# Consolidated Edison Company of New York

## Indian Point 2

### Steam Generator Inspection 2000

Technical Meeting

**Figure RAI-1-1. Indian Point-2: POD vs. Burst Effective Crack Area  
Nominal, Lower 95% and Lower 99% Confidence Levels**

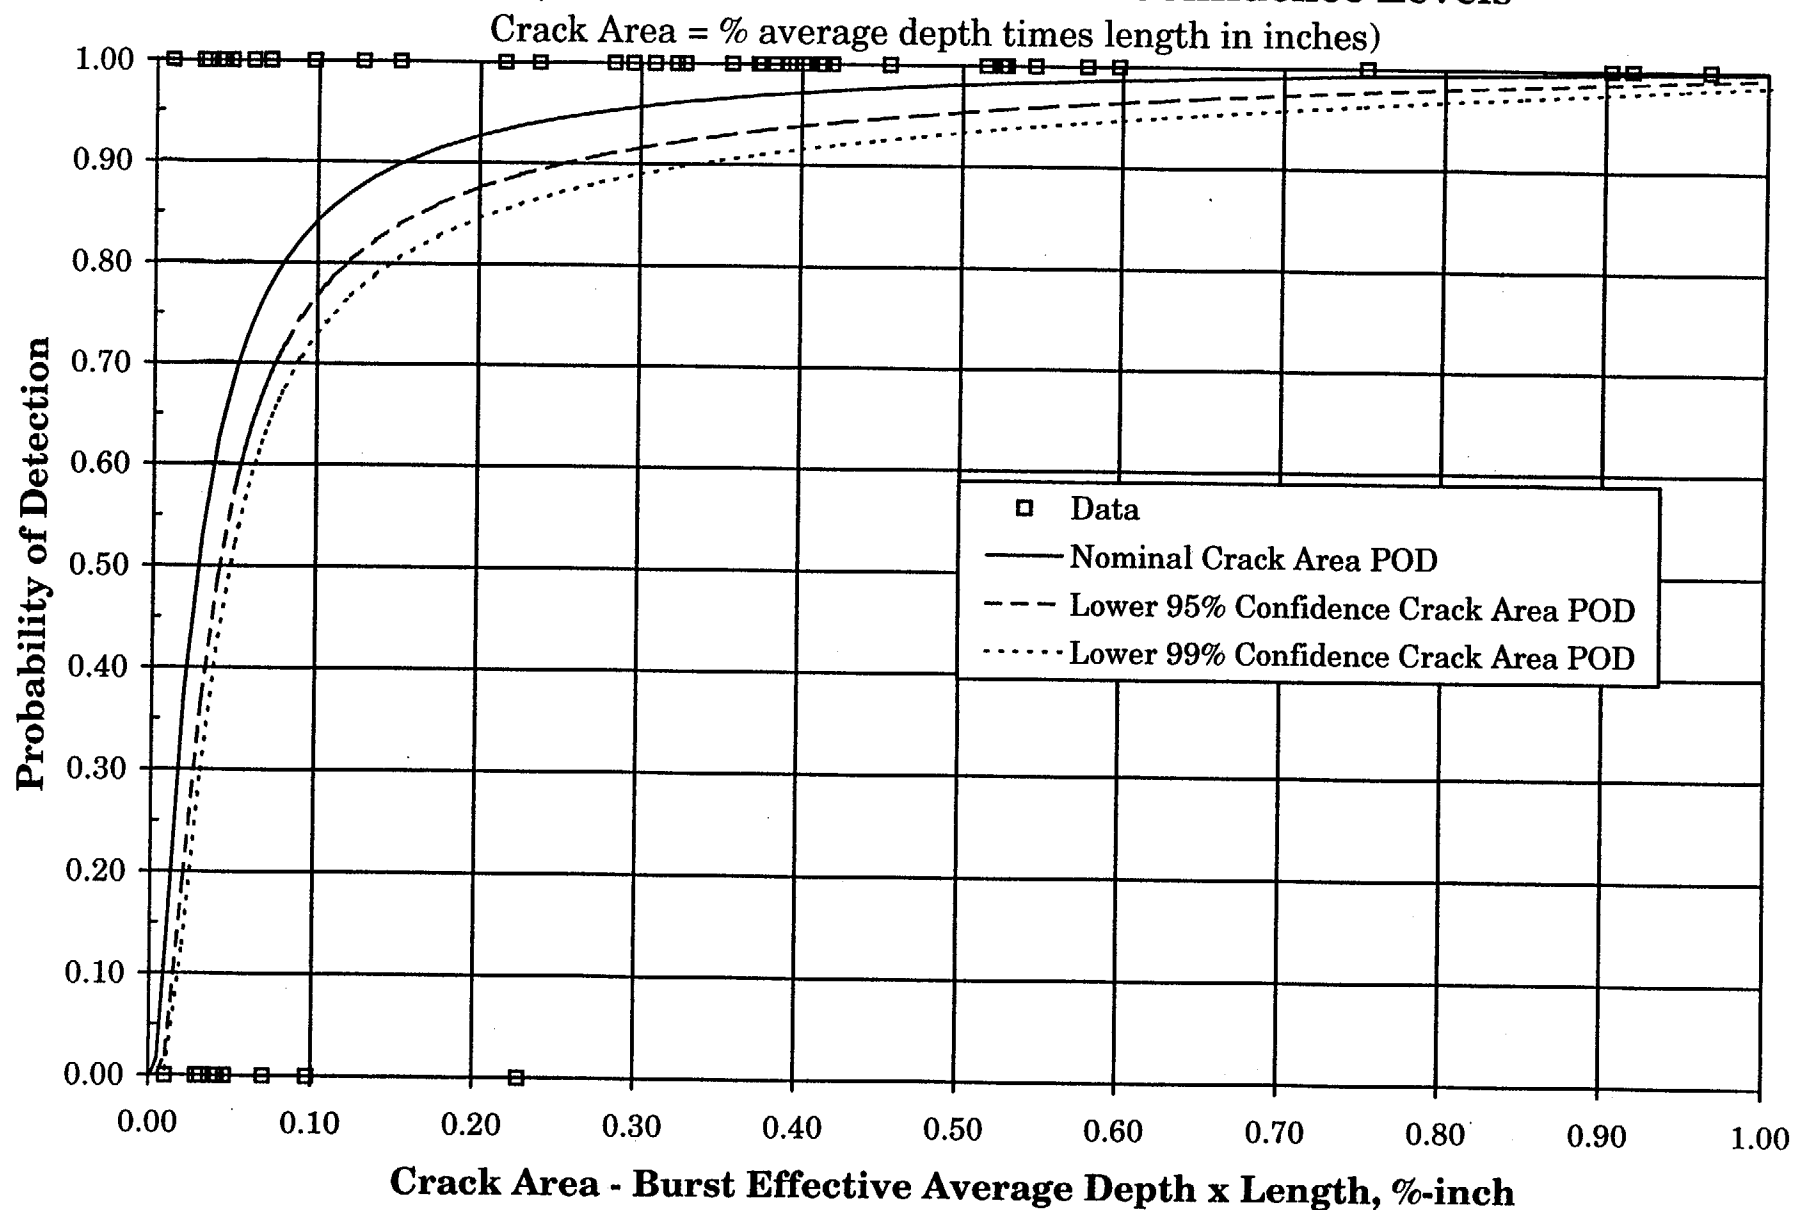
- **Provide a chart showing the 95% confidence bounds on POD fit to the crack area**

**Figure RAI-2-1. Indian Point-2: POD vs. Average Crack Depth Including PODs at Lower Confidence Levels and with Depth Shifts**

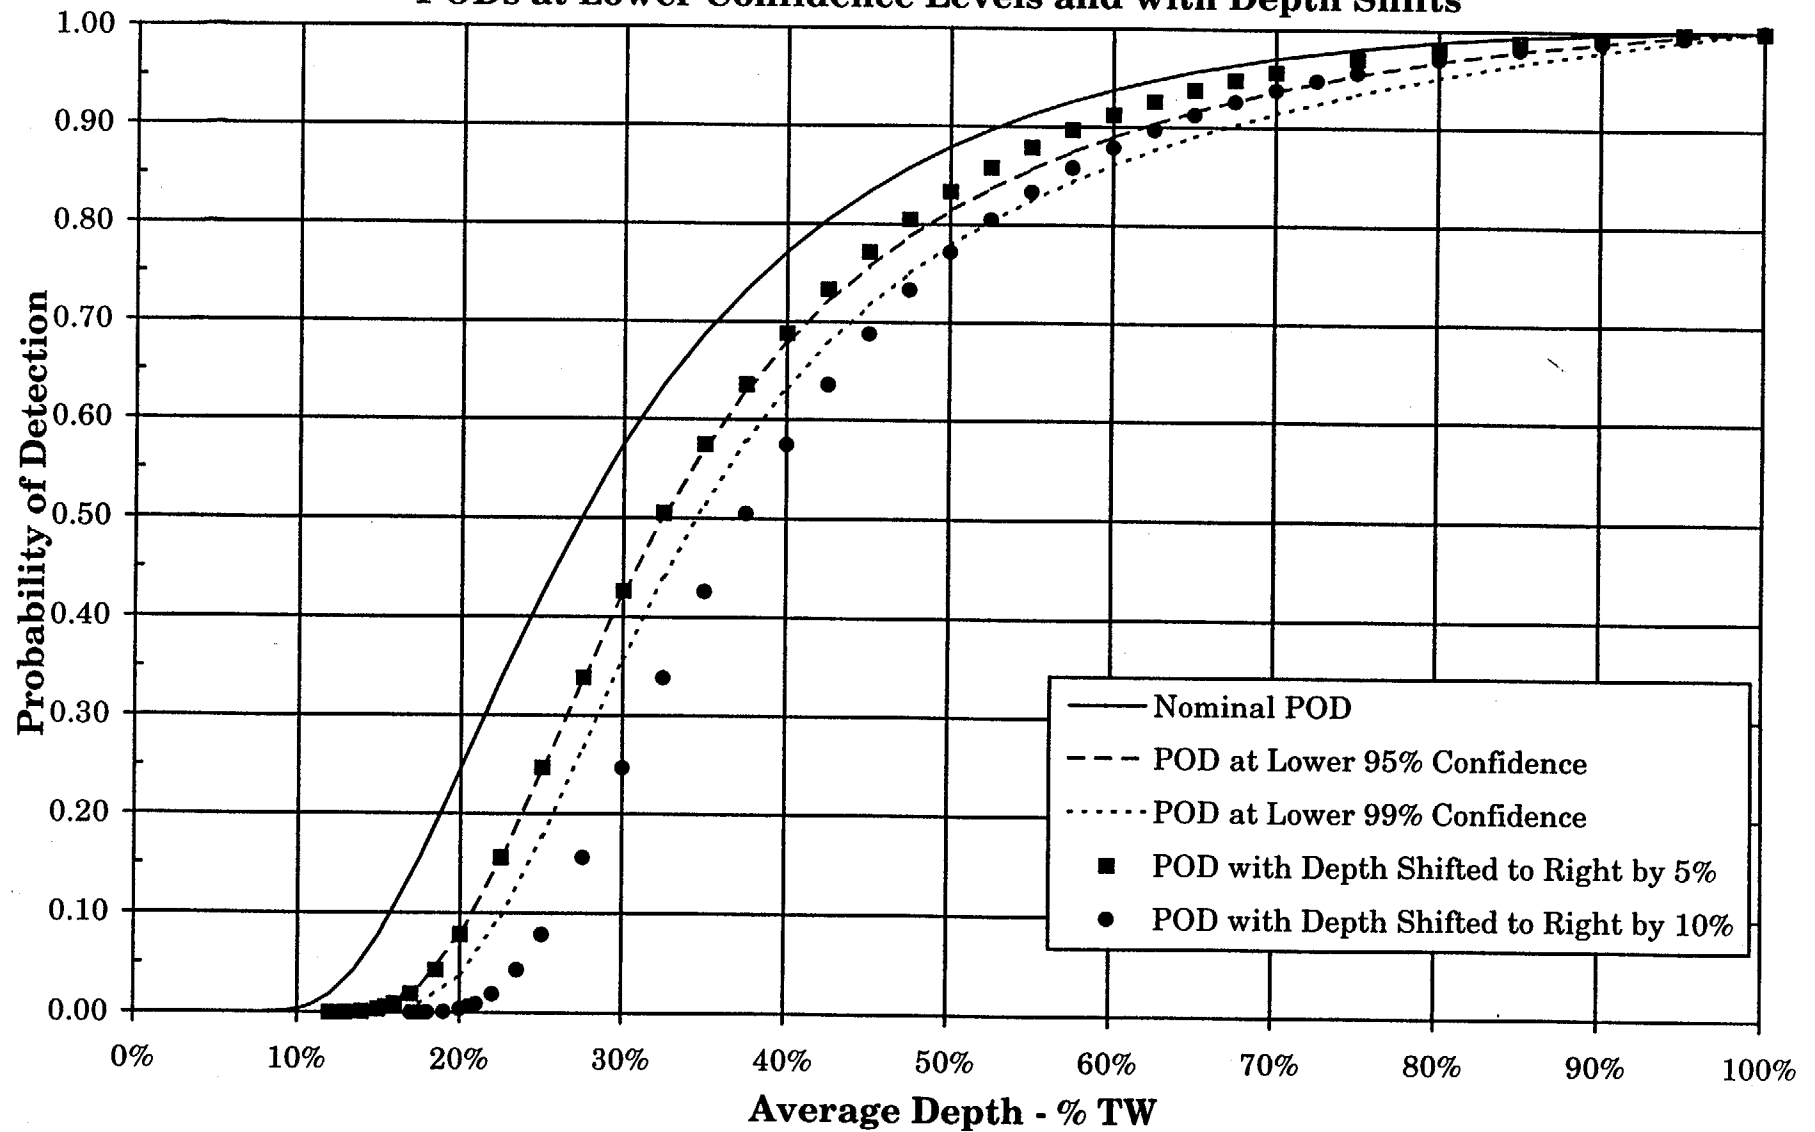
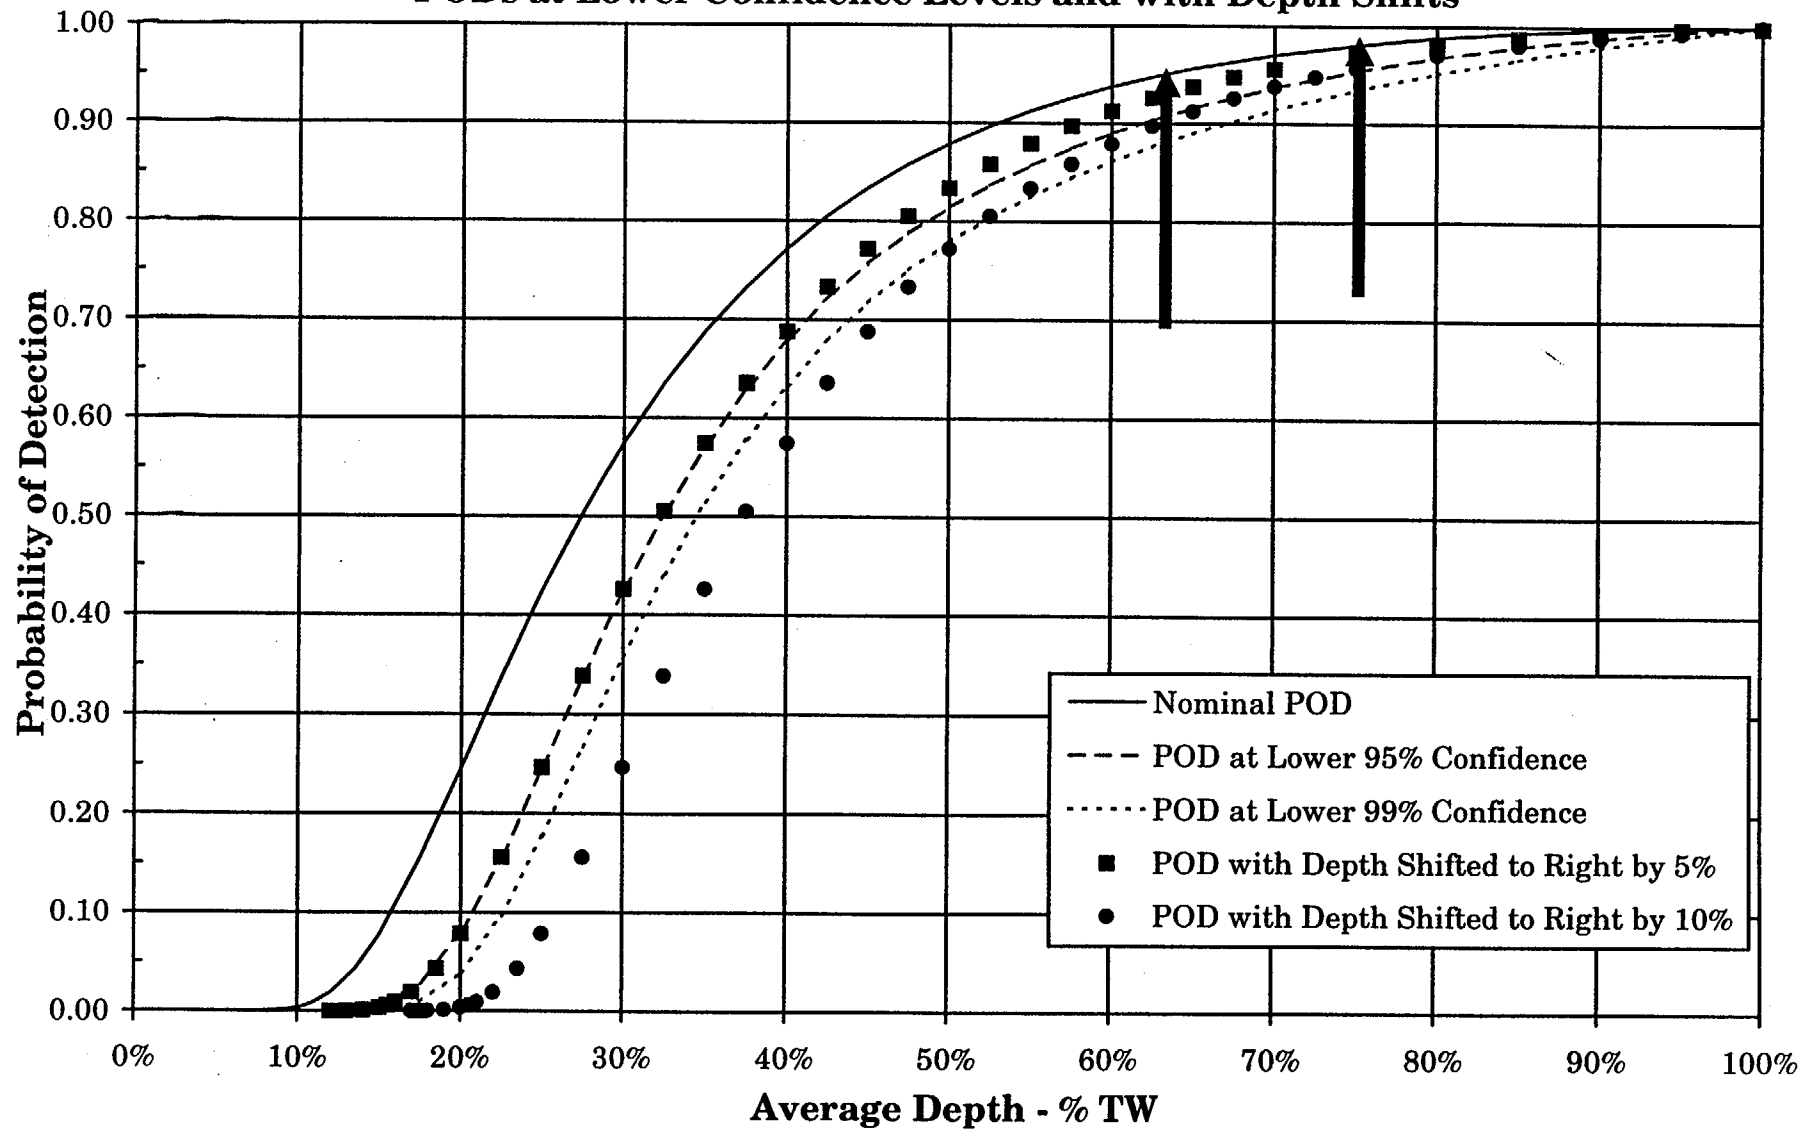
- **What is the sensitivity of the CMOA to a 10% shift of the POD in % TW**

**Table RAI 2-1. Indian Point-2 Cycle 15 SG Depth-Based POD Sensitivity Analyses  
Projected Burst Pressures and Leak Rate<sup>(1)</sup> for the Limiting SG 24 - 400 kHz Profiles**

**Figure RAI-3-1. Indian Point-2: POD vs. Burst Effective Crack Area  
Including PODs at Lower Confidence Levels and with Crack Area Shifts**

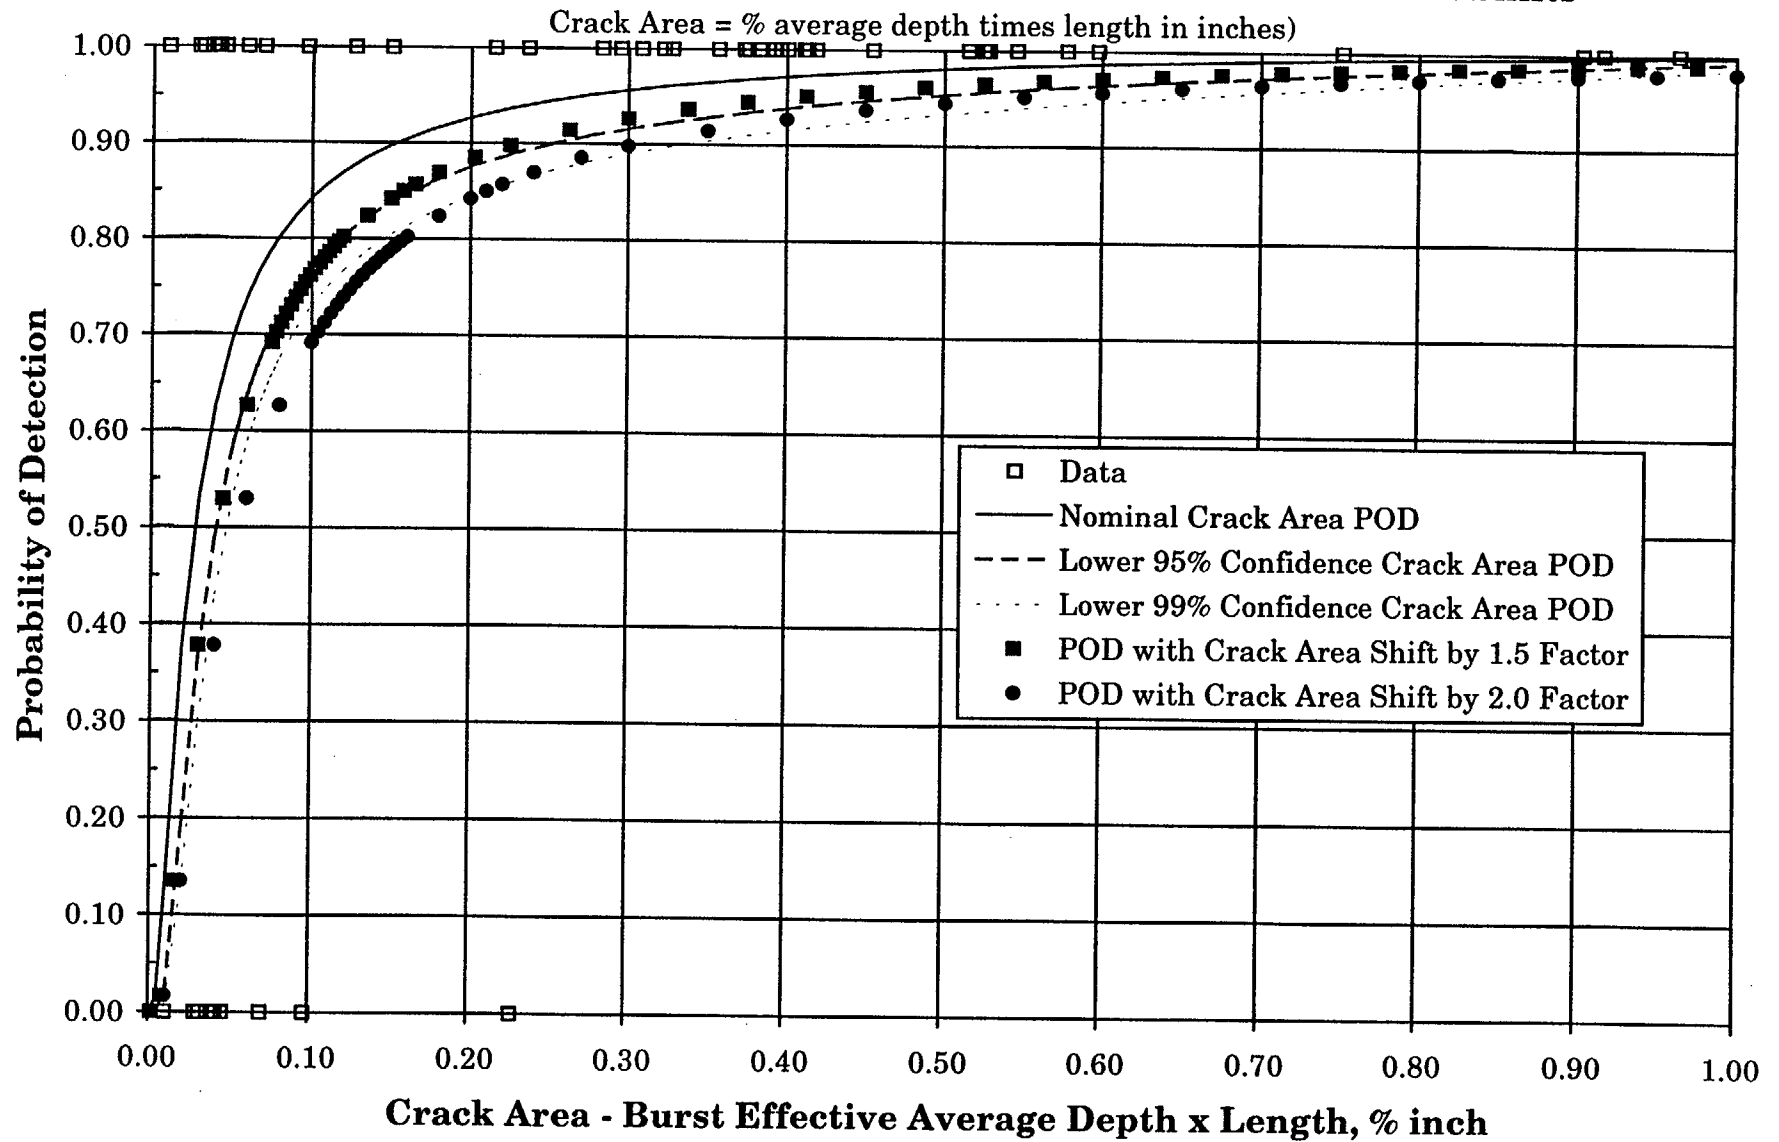
- **Provide sensitivity analysis to a 50% and 100% shift in area-based POD for a given POD value**

**Table RAI 3-1. Indian Point-2 Cycle 15 U-Bend Crack Area POD Sensitivity Analyses  
Projected Burst Pressures and Leak Rate<sup>(1)</sup> for the Limiting SG 24 - 400 kHz Profiles**

IP2 R3 Composite RT Stress-Strain Curve  
(curve based on typical  $\sigma$ - $\epsilon$  curve)

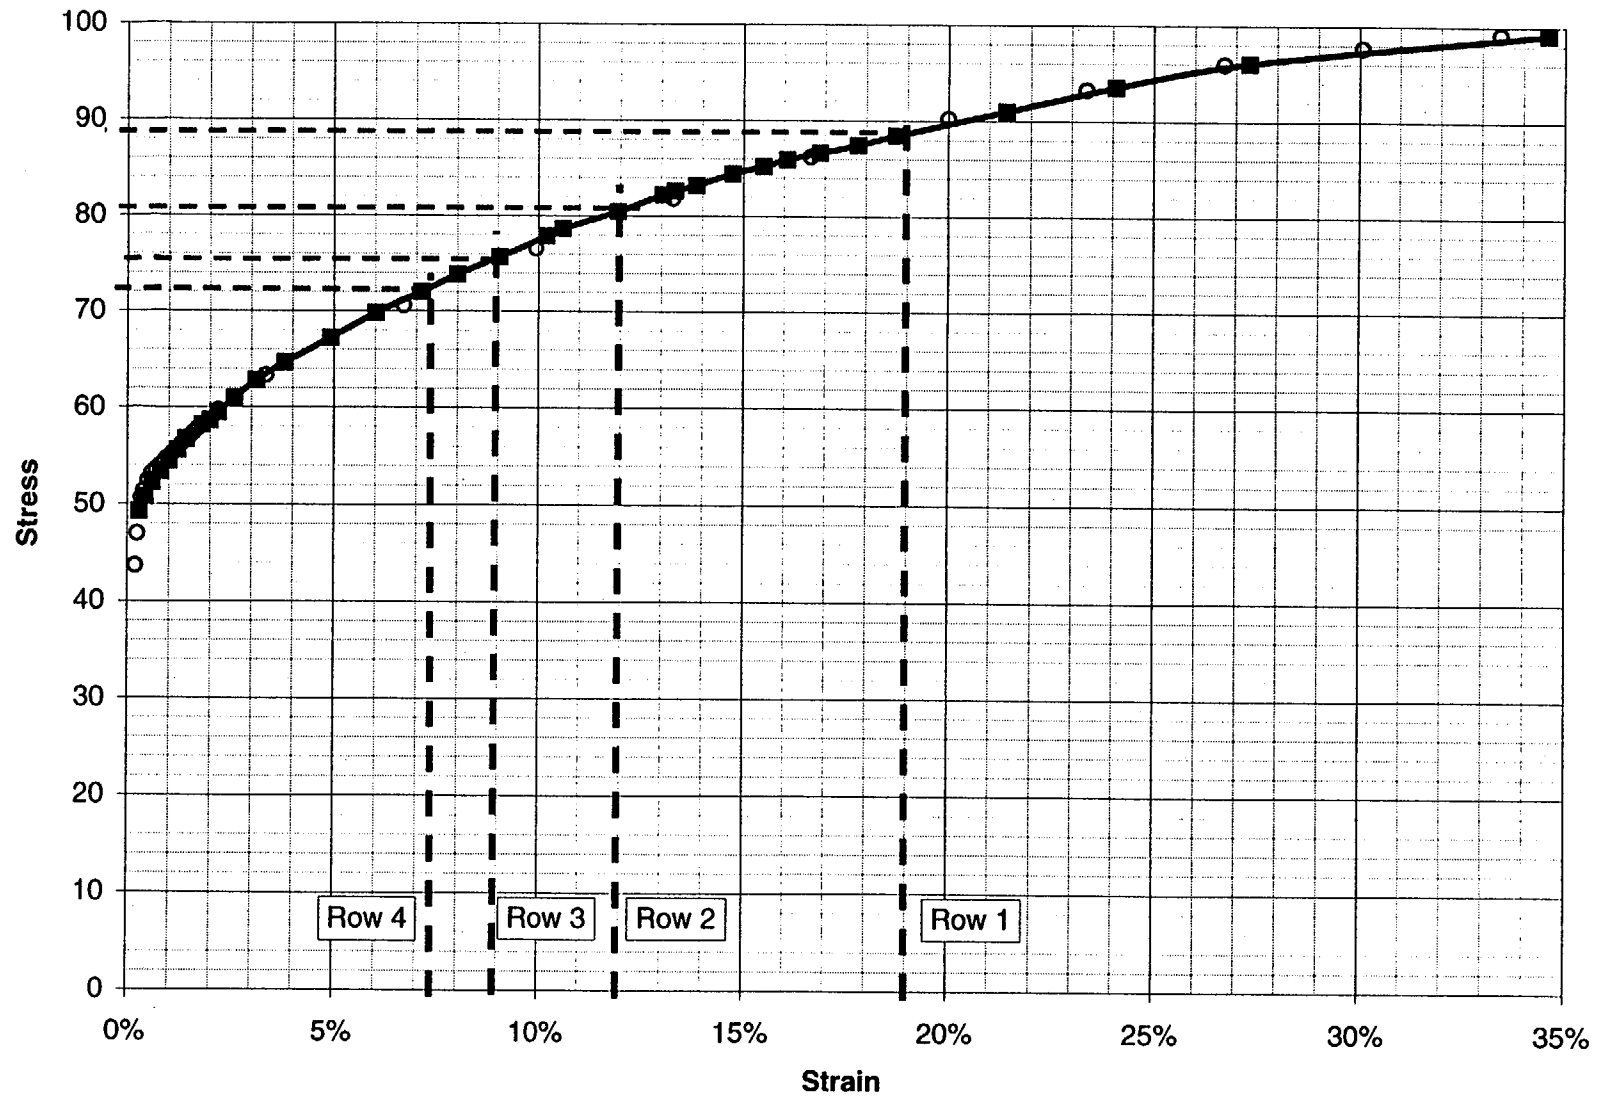
- **Discuss the basis for the assumption that the material flow stress is invariant with the initial non-strain hardened material properties. Consider:**
  - **CMTR uncertainty distribution or 95 / 95 tolerance limit**
  - **Temperature and strain hardening**

- **CMOA uses an estimated lower bound flow stress**
- **CMOA is not dependent on the assumption that the flow stress is invariant**
- **Lower bound value yields more conservative burst pressure than CMTR material property distribution**
  - **Calculation provided to demonstrate conclusion**
